Wendy's Restaurant

MEMORANDUM

To: Building Inspector
From: Planning Department
Date: May 20, 2022
Subject: Building Permit Application for Wendy's Restaurant
3399 Crompond Road, *aka* Staples Plaza
SBL: 36.06-2-76

SHEET NAME
**ARCHITECTURAL
 SITE PLAN**

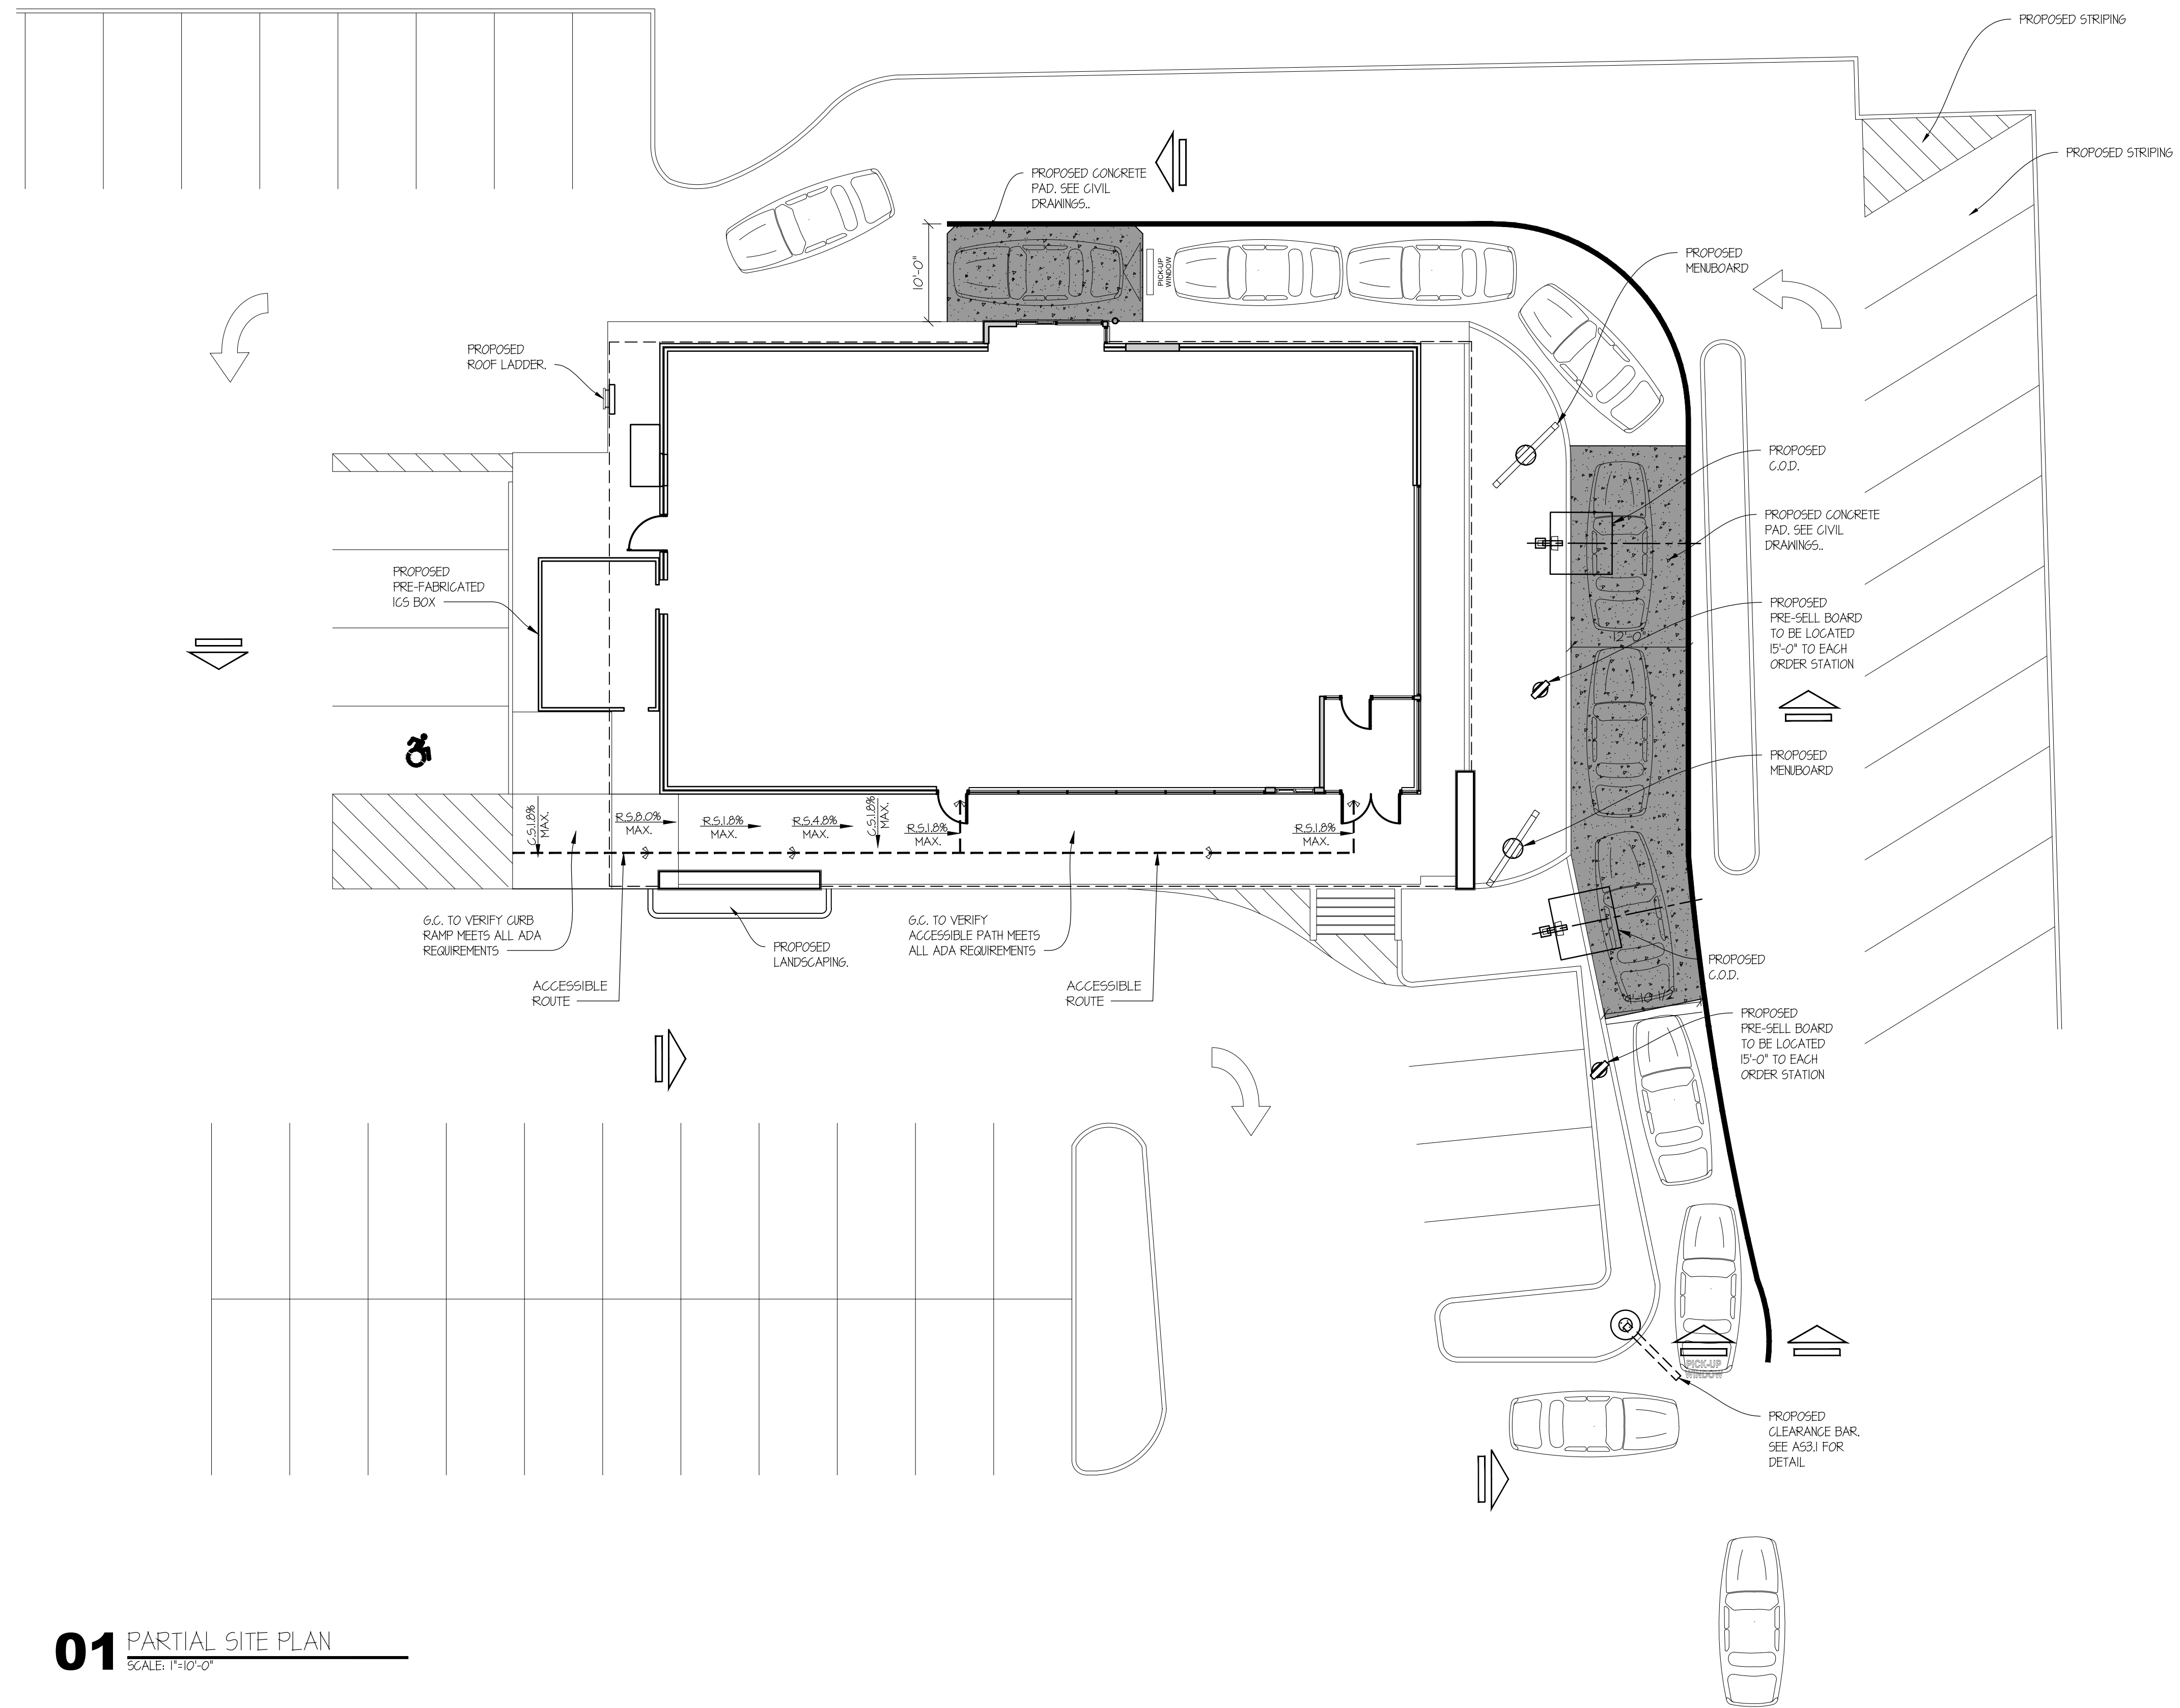
The project proposes site modifications to the area of the existing drive-thru queueing lane and immediate environs. New ordering stations and menu boards along the drive-thru lane are proposed in the adjacent landscape island. It is unclear as to the impact on the landscaping or any proposed modifications thereto. Further, the adjacent parking area is proposed to be restriped from perpendicular spaces to diagonal spaces. It is unclear as to the number of spaces being displaced or reduced or if there is any impact on operational values. **This triggers Planning Board review.**
